Addendum No. 3 to IFB 16-48

To: All Parties on Record with the City of Somerville as Holding **IFB 16-48**
Cedar St Sewer Separation

Re: Extended Due Date, Revised Unit Price Form, Updated Specifications, Select, Revised Drawings/Plans

S-8

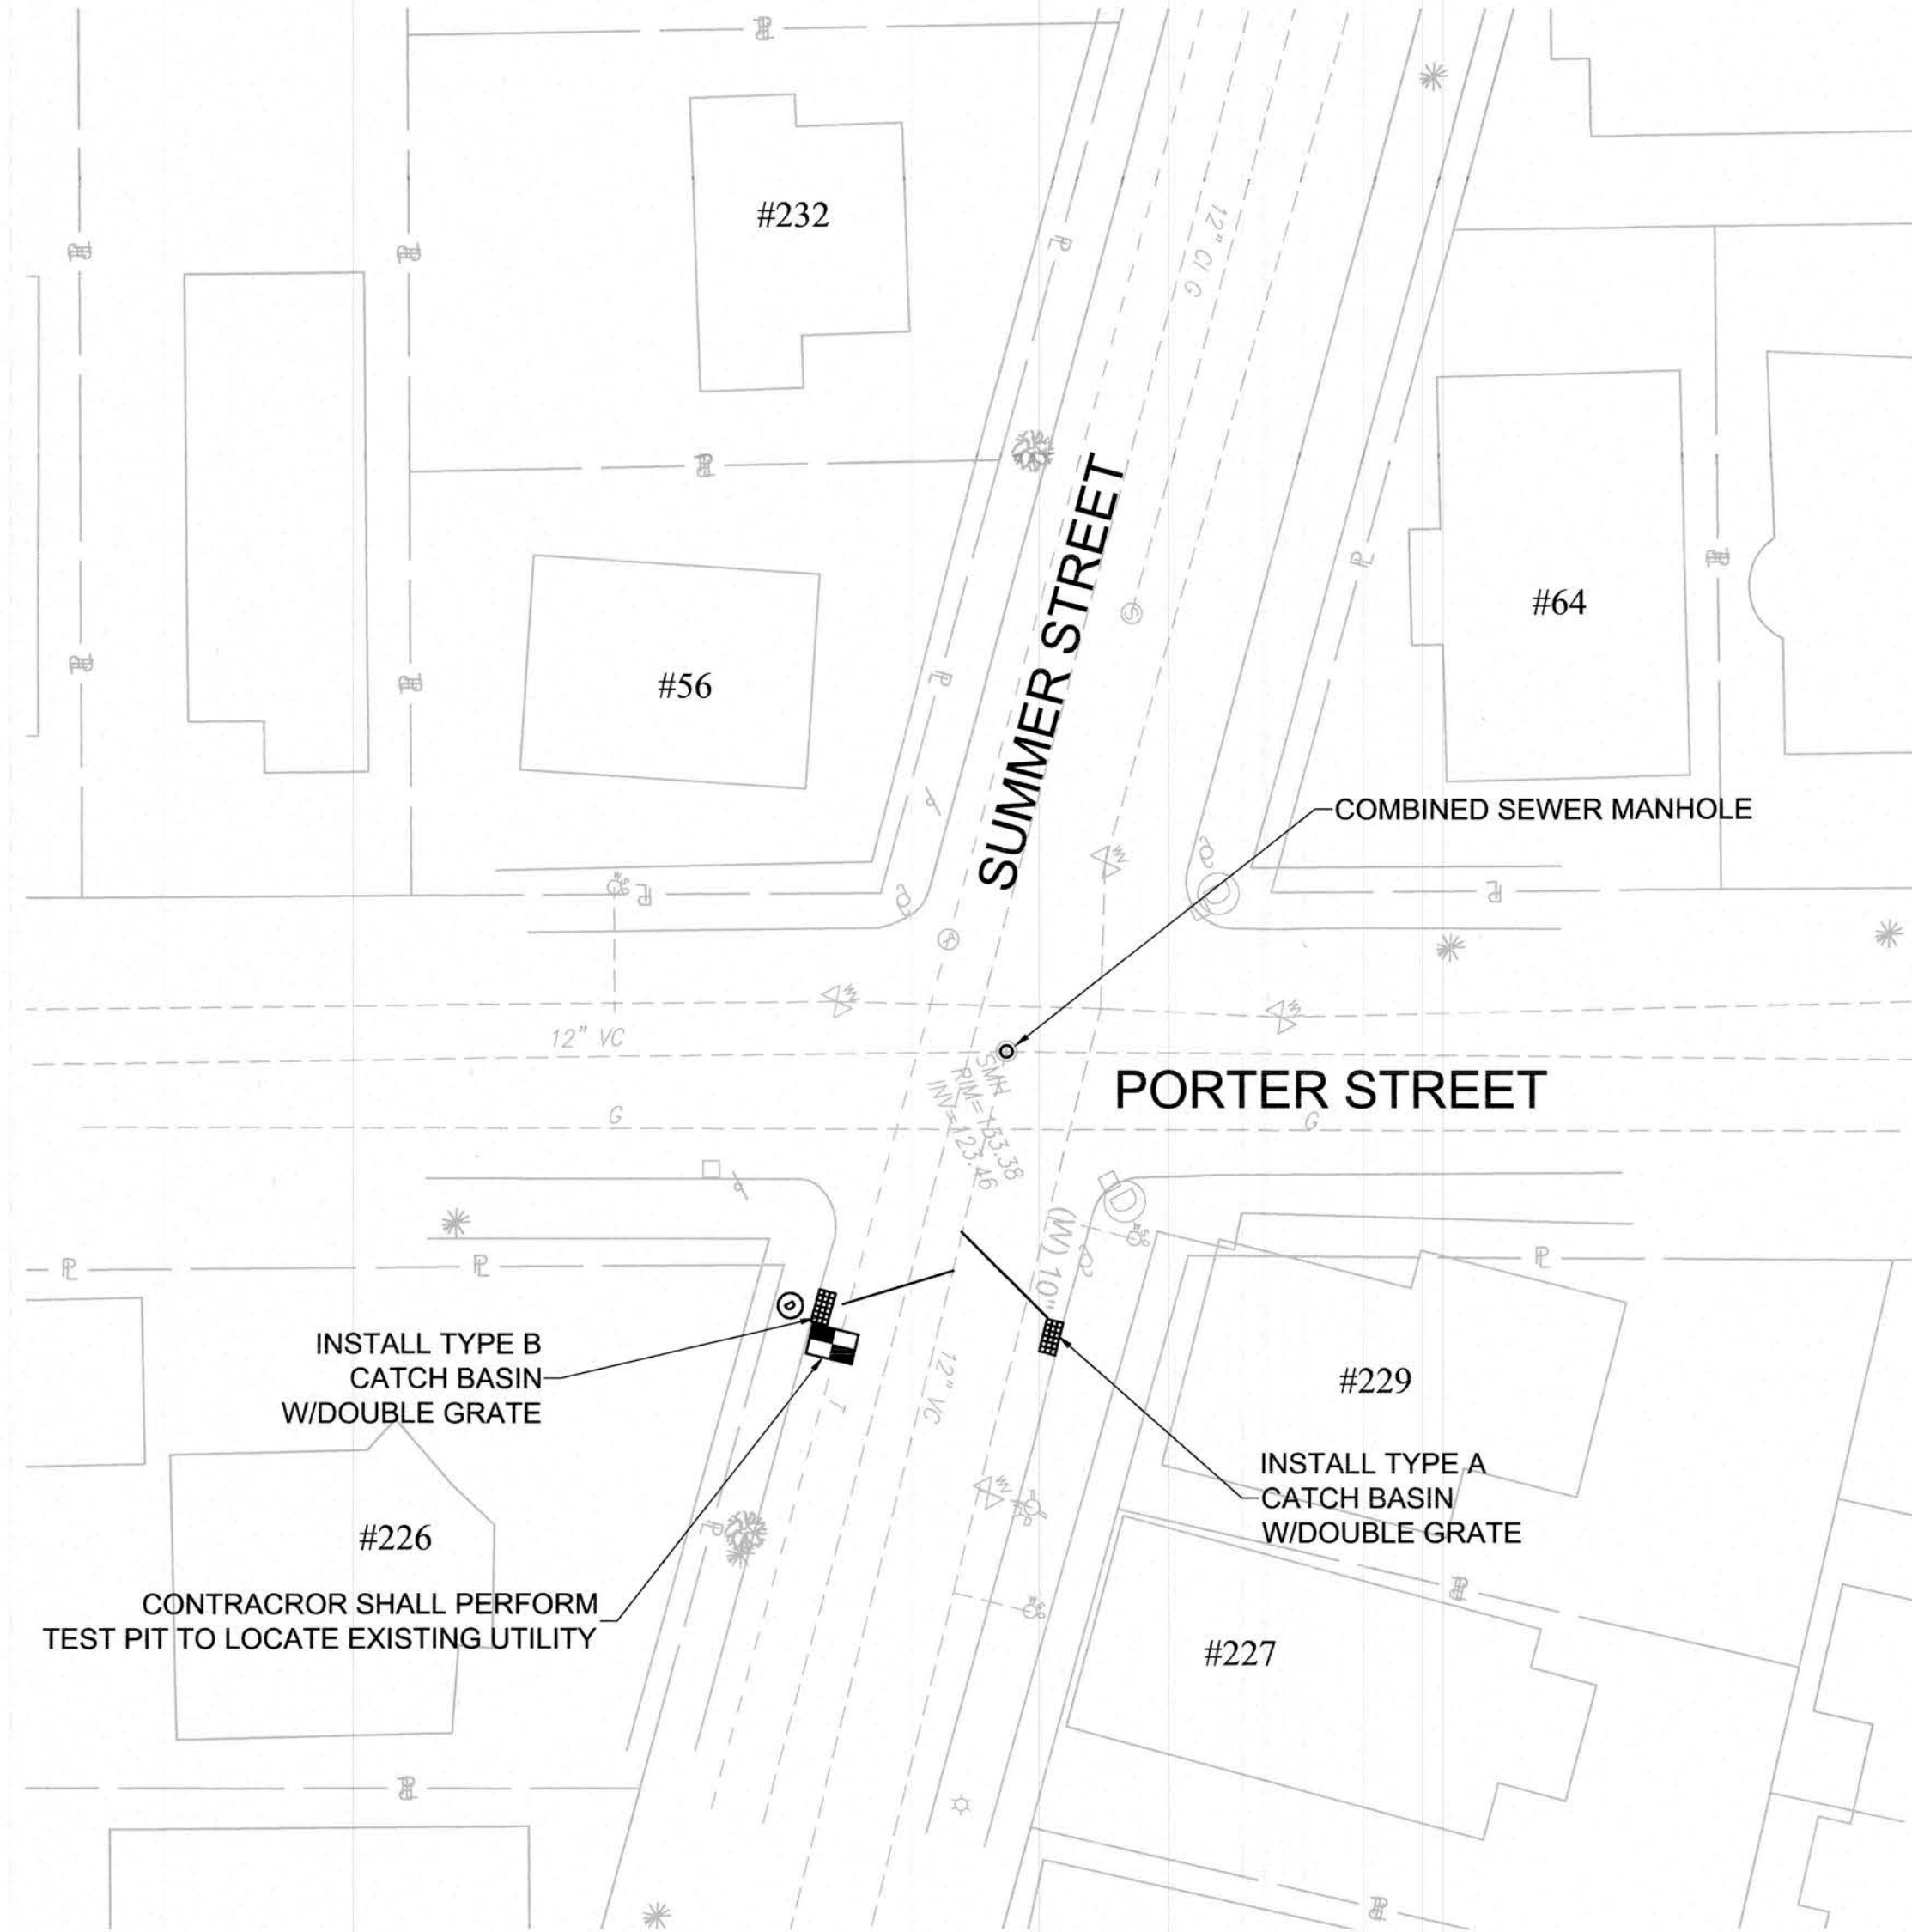
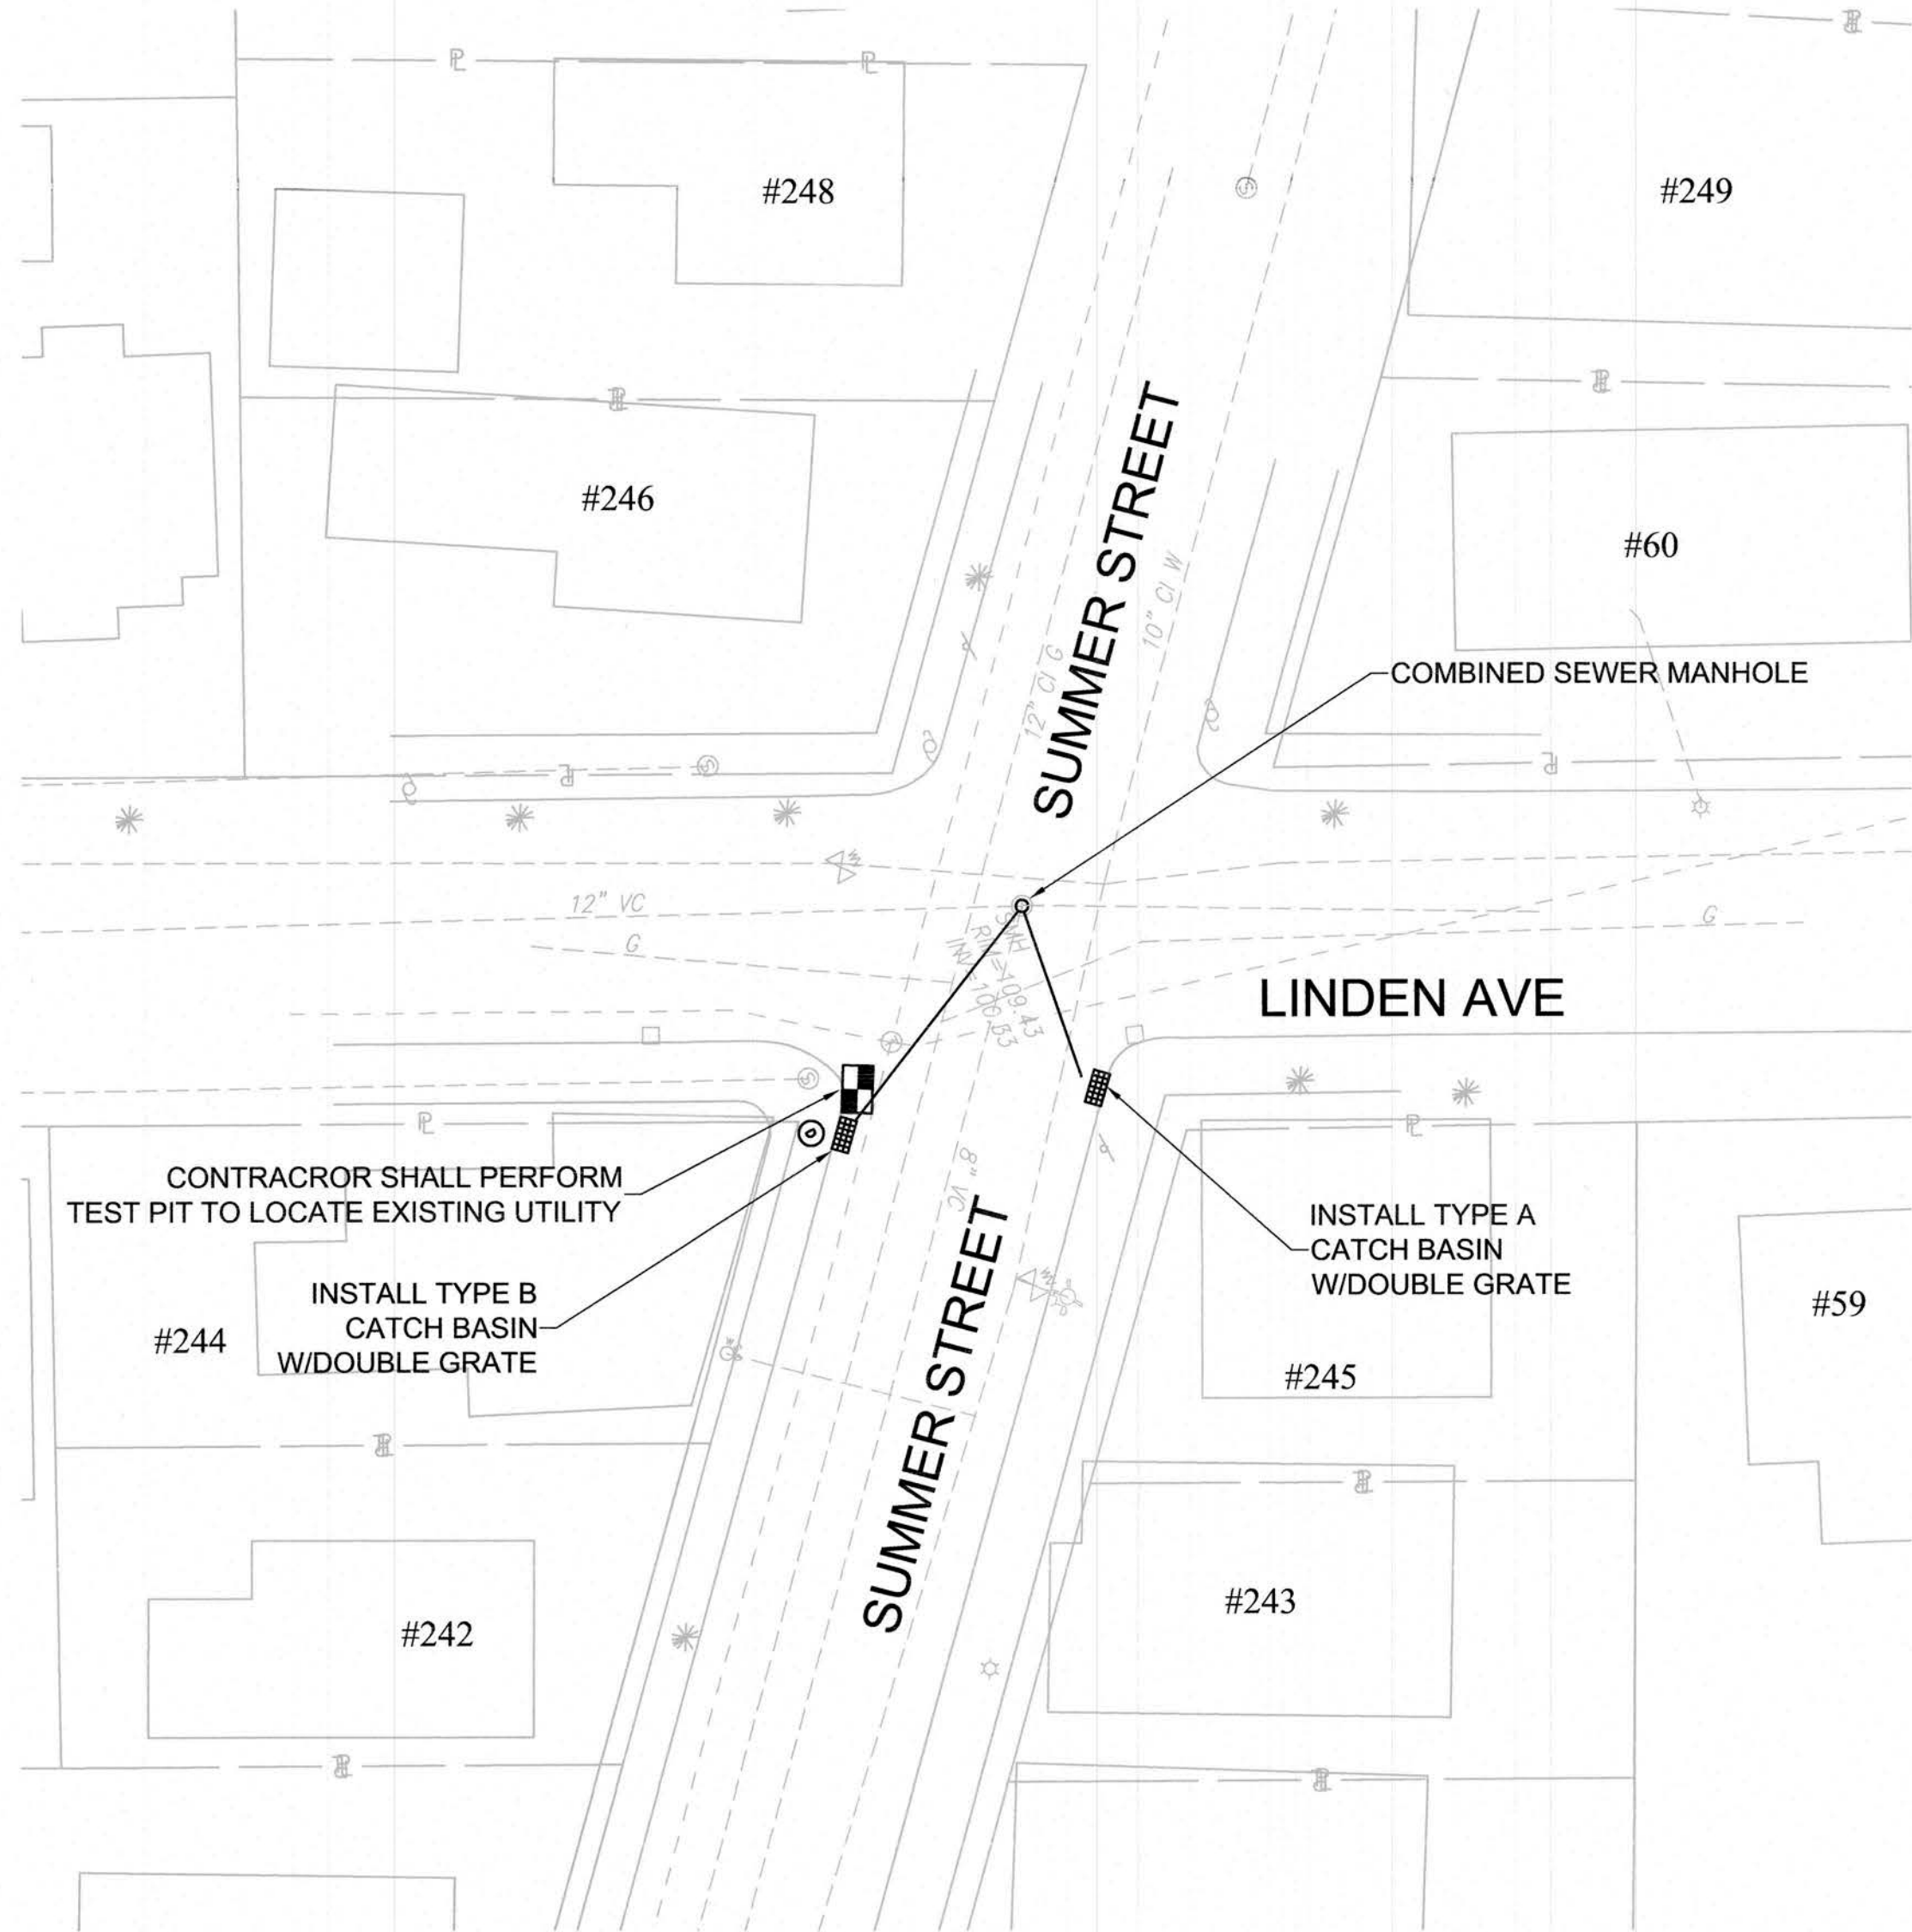
Q: It is noted that there is a need for manhole rehabilitation required by cementitious means. Please advise.

A: *Manholes to be rehabilitated with cementitious liner are indicated on the construction plans on Sheets S-2, S-3, and S-8. See Specifications Section 02439, Cementitious Lining of Manholes.*
